STAFF RECOMMENDATION 1709 4th Avenue North June 20, 2018

Application: New construction – infill; Setback determination
District: Salemtown Neighborhood Conservation Zoning Overlay
Council District: 19
Map and Parcel Number: 082053A90000CO
Applicant: Brad Sayers, Four Square Design Studio
Project Lead: Sean Alexander, sean.alexander@nashville.gov

Description of Project: The applicant is proposing to construct a new two-story house, replacing a non-contributing house that has been approved for demolition. The house is proposed to be thirty-one feet, six inches (31'-6") tall, and thirty-one feet, six inches (31'-6") wide. The building is wider than the bulk zoning setback regulations permit.

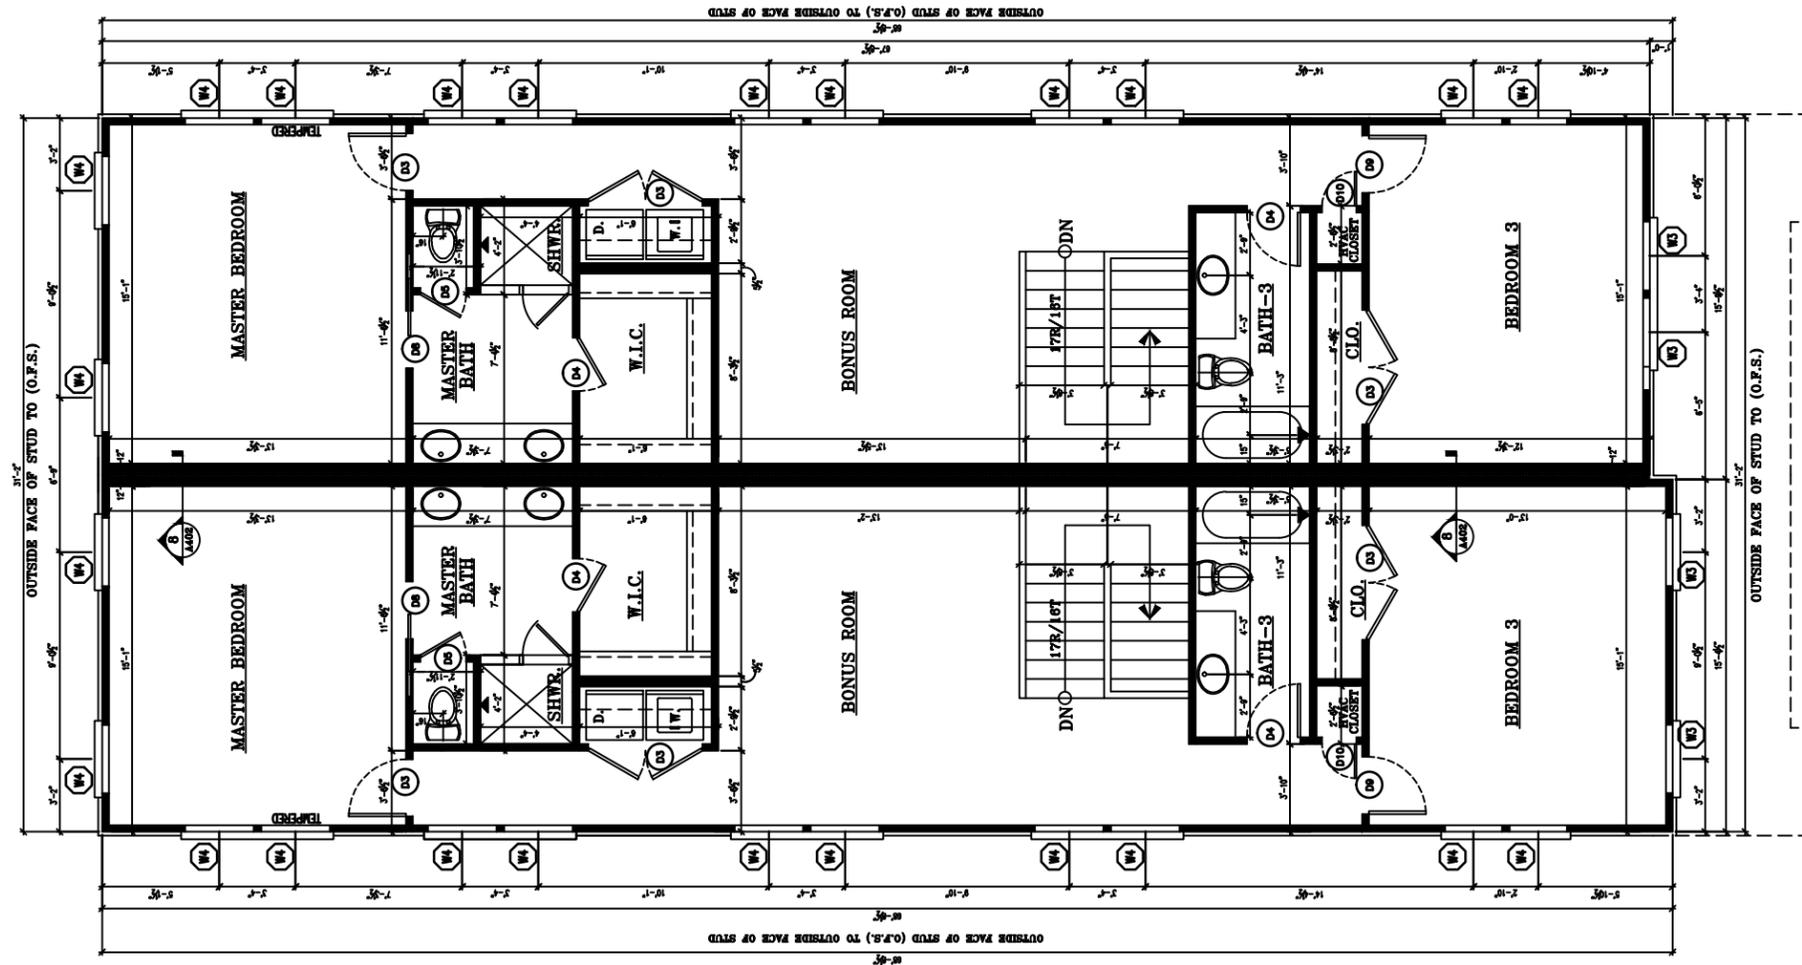
The building will be thirty-one feet, six inches (31'-6") wide at the front. There are historic houses on the block on similar-sized lots as wide as thirty feet (30'), but they are all only one story. The proposed building will be sixty-eight feet (68') deep, with a front porch increasing the depth to seventy-four feet (74'). There are historic houses nearby as deep as forty feet (40') to fifty feet (50'), but again they are all one story and they typically narrow toward the rear. (Note that the plans label the dimensions of the building from the "outside face of stud to outside face of stud." Staff measured the building using the outside dimensions with exterior cladding.)

Staff finds that although the height of the infill would meet the design guidelines, the width of the building is not appropriate and therefore the massing of the proposed new building as submitted is not compatible with the surrounding historic context and does not meet sections III.A.1 and III.B.1 of the design guidelines. Staff recommends that the width of the building is reduced to a maximum of twenty-seven feet, six inches (27') in order to be more compatible with the historic context and to meet the bulk zoning regulations.

3. The front setback shall be consistent with setbacks of the adjacent historic houses, to be verified by MHZC staff in the field;
4. The width of the principal building is reduced to twenty-seven feet, six inches (27'-6");

REAR ELEVATION
SCALE: 1/8" = 1'-0"

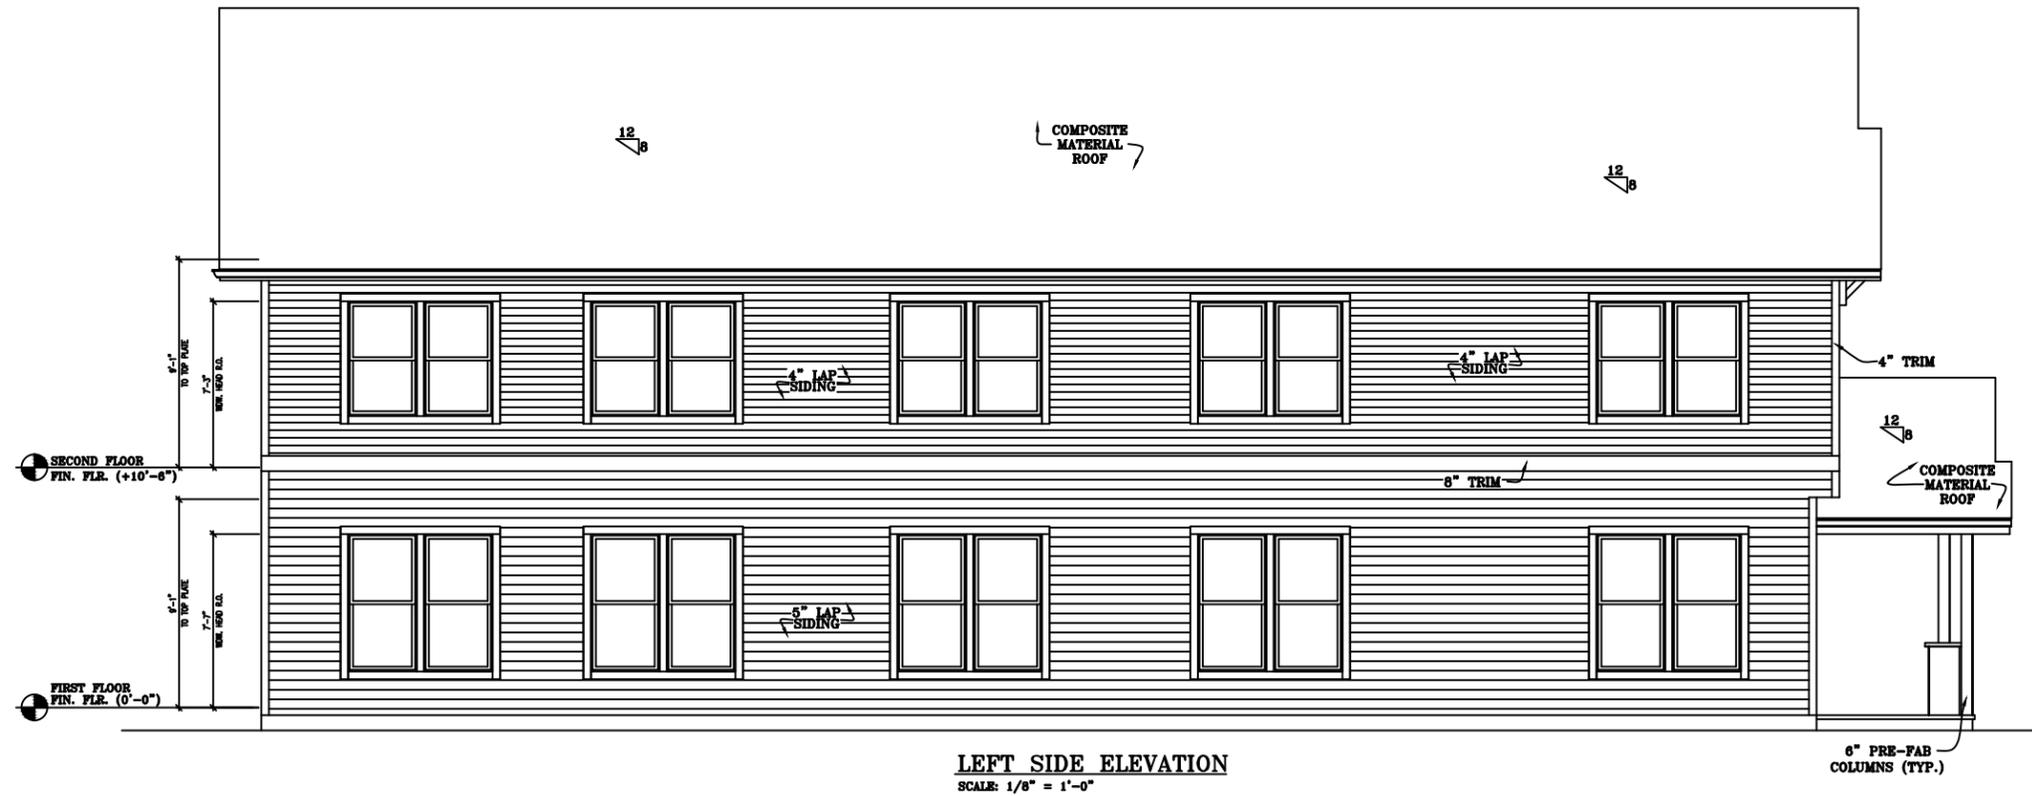
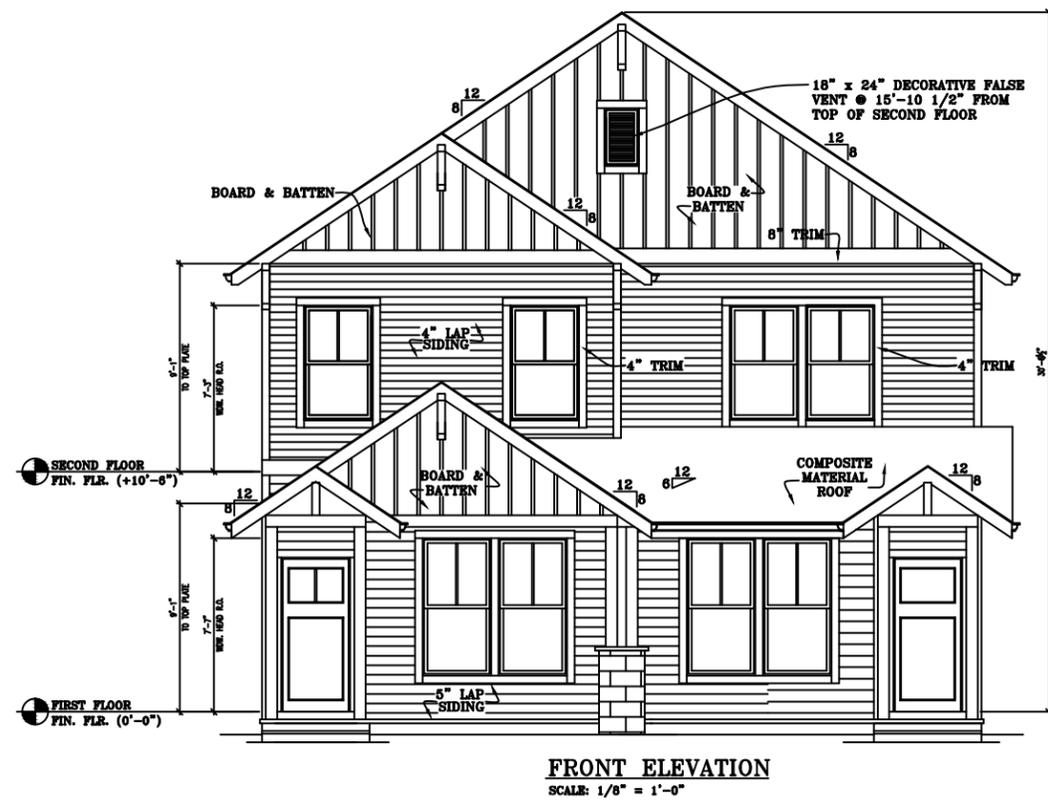
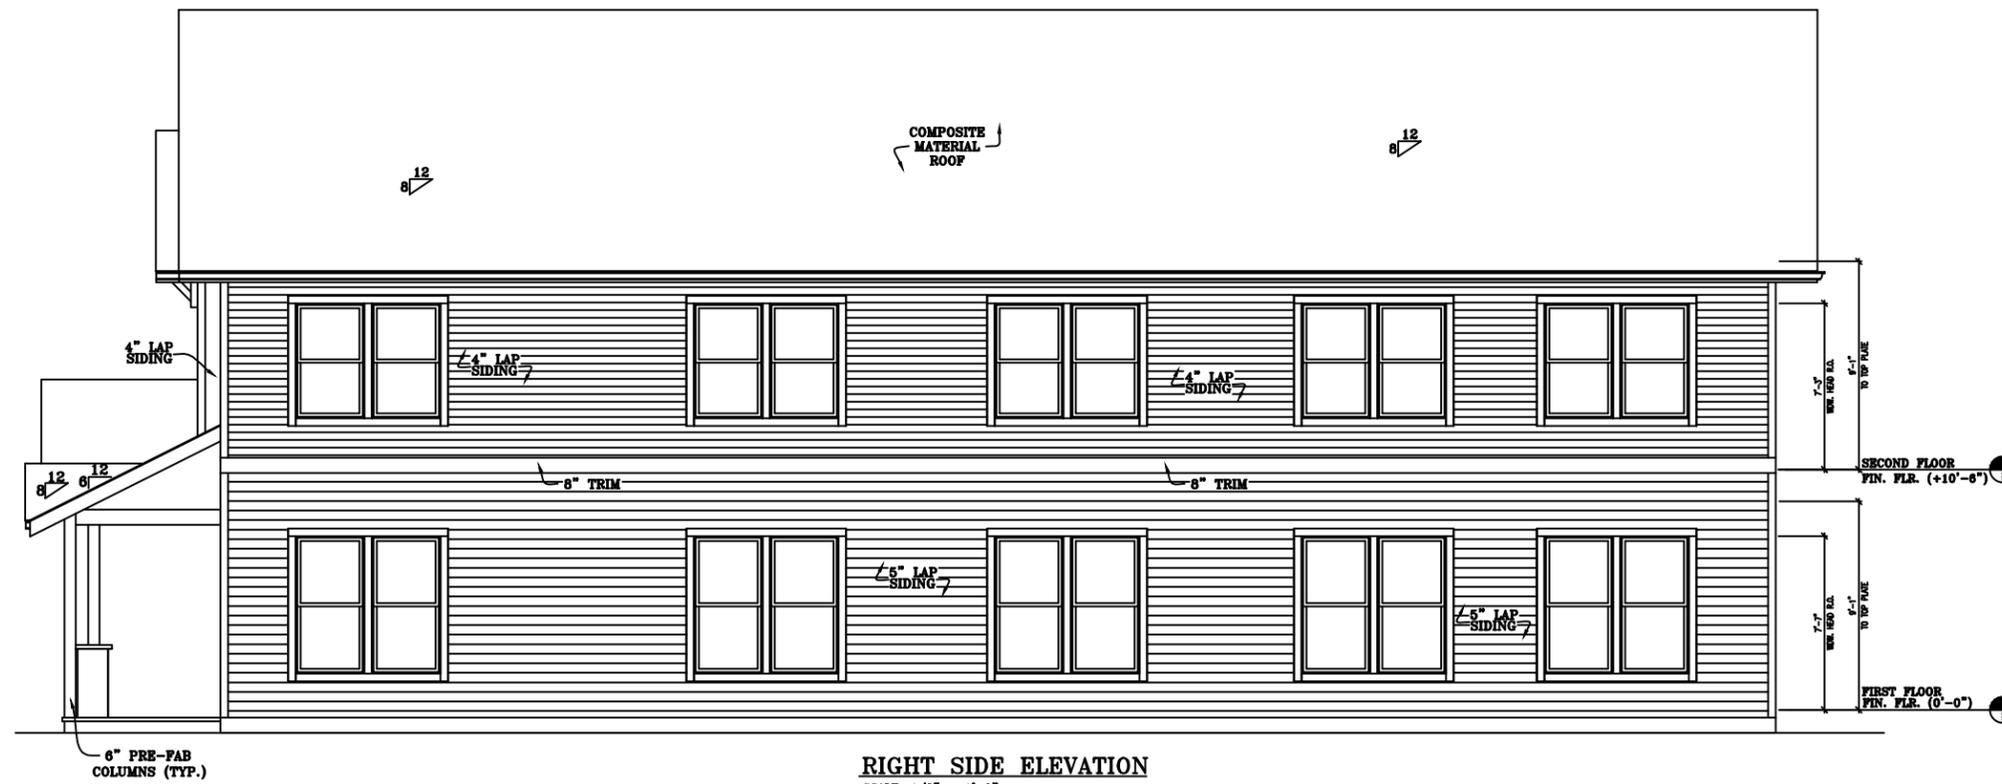
Height & Scale: The new building will be thirty feet, six inches tall (30'-6") from the floor level to the peak of the roof, with a corresponding eave height nineteen feet. The plans indicate that the height of the finished floor is to be one foot (1') above grade. However, Staff recommends that the floor height of the building at the front be constructed higher to be more consistent with surrounding historic houses, relative to natural grade. For example, the floor height of the adjacent house is approximately two feet, nine inches (2'-9") above grade. Matching this would make the actual height of the proposed building thirty-three feet, three inches (33'-3") tall. This would still meet the design guidelines for infill in the Salemtown overlay which allows infill to be two stories up to thirty-five feet (35') tall. With the condition that the floor height of the building is consistent with surrounding historic houses, Staff finds the height of the proposed infill will be compatible with surrounding context.

Roof form: The primary roof of the building will be a front-oriented gable with a pitch of 8:12. The building will have a full width front porch, the right half of which will be under a 6:12 shed roof and the left half under an 8:12 gable. A smaller accent gable will indicate the building's two primary entrance locations. These roofs on the proposed building will be compatible with surrounding houses will therefore meet section III.E of the design guidelines.

Proportion and Rhythm of Openings: The window and door openings on the new building will generally be twice as tall as they are wide, as is typical of houses nearby historically. The majority of windows will be double-hung with 2/1 sashes on the front and 1/1 on the side. The windows will be regularly spaced without any large expanses of blank wall without an opening and with a four inch (4”) mullion between paired windows. Staff finds that the window proportions and rhythms are generally compatible with the surrounding historic context and that the project will meet section III.G of the design guidelines.

1. The floor height of the principal building, relative to natural grade, is consistent with surrounding historic houses;
2. The finished floor height shall be consistent with the finished floor heights of the adjacent historic houses, to be verified by MHZC staff in the field;

REAR ELEVATION
SCALE: 1/8" = 1'-0"

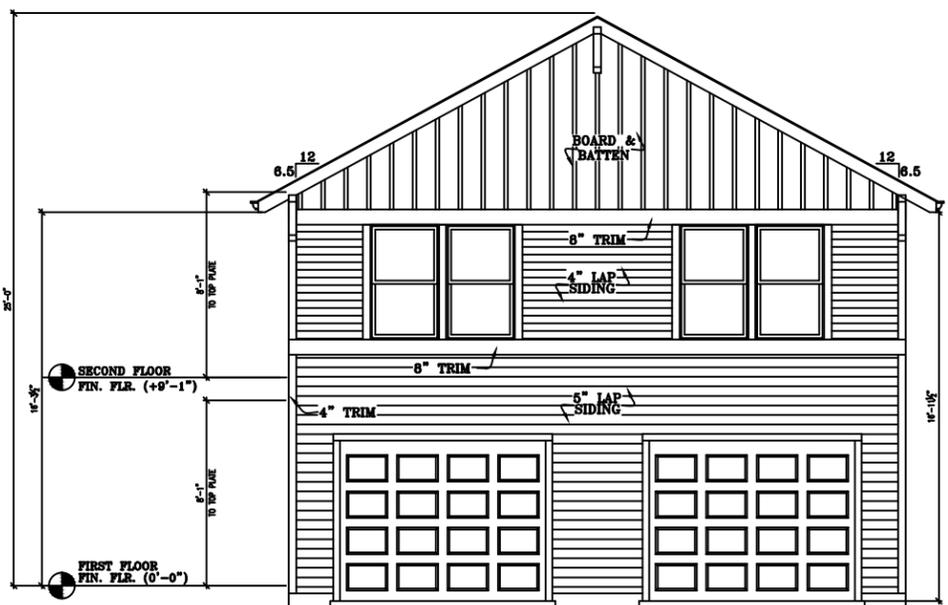
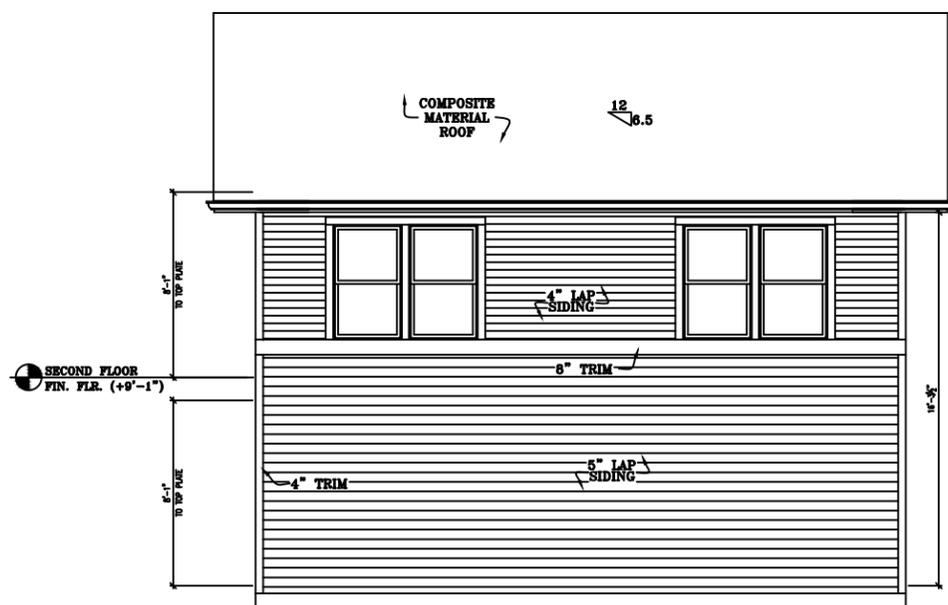
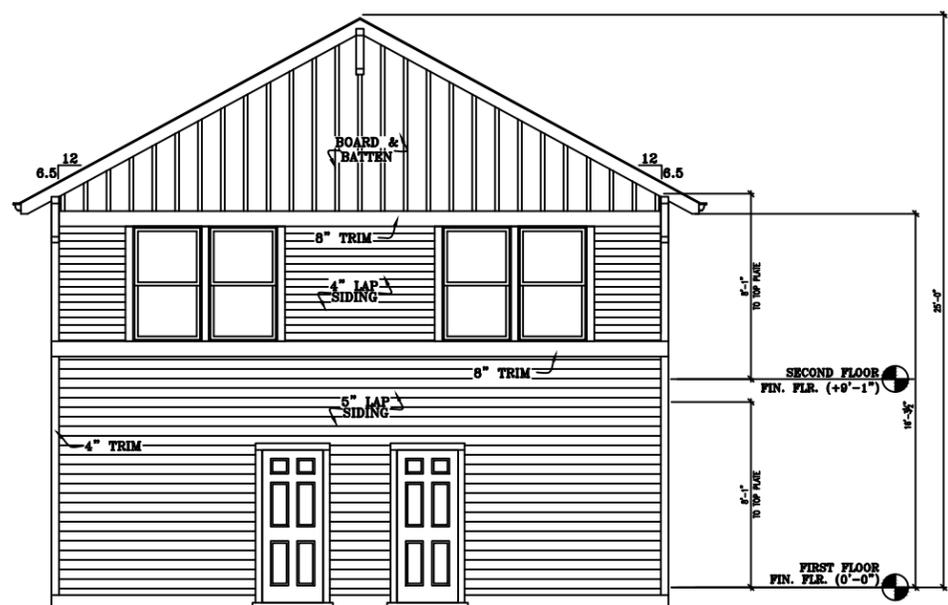
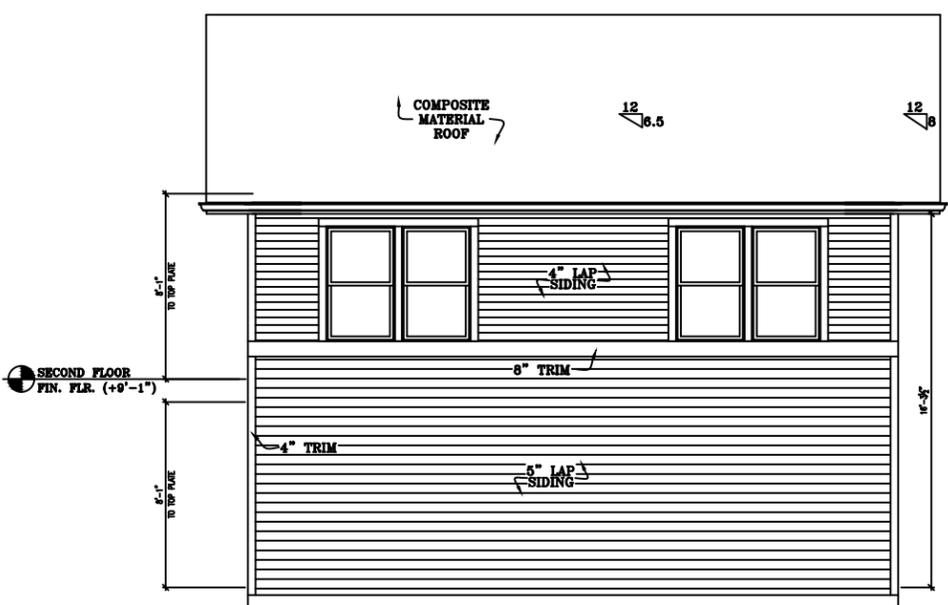
The height of the outbuilding will be twenty-six feet (26'), which is one foot (1') taller than is permitted under the design guidelines. The building's area will be seven hundred, seventy square feet (770 sq. ft.), which is twenty square feet (20 sq. ft.) greater than is permitted under the design guidelines. (Note that the plans label the dimensions of the building from the "outside face of stud to outside face of stud." Staff measured the building using the outside dimensions with exterior cladding.) With the condition that the height of the building is reduced to twenty-five feet (25') and the area reduced to seven hundred, fifty square feet (750 sq. ft.), Staff finds the height and scale of the proposed outbuilding will meet sections III.A, III.B., and III.H of the design guidelines.

Design Standards: The materials, proportions, and overall character of the accessory structure will be similar to the historic house. Its roof will be gabled with a 6.5:12 pitch, which would not contrast greatly with the roof on the house. The window proportions and locations are compatible with those of outbuildings historically. Staff finds the design of the proposed outbuilding to meet section III.H of the design guidelines.

5. The height of the outbuilding shall be reduced to twenty-five feet (25') and the area shall be reduced to seven hundred, fifty square feet (750 sq. ft.);
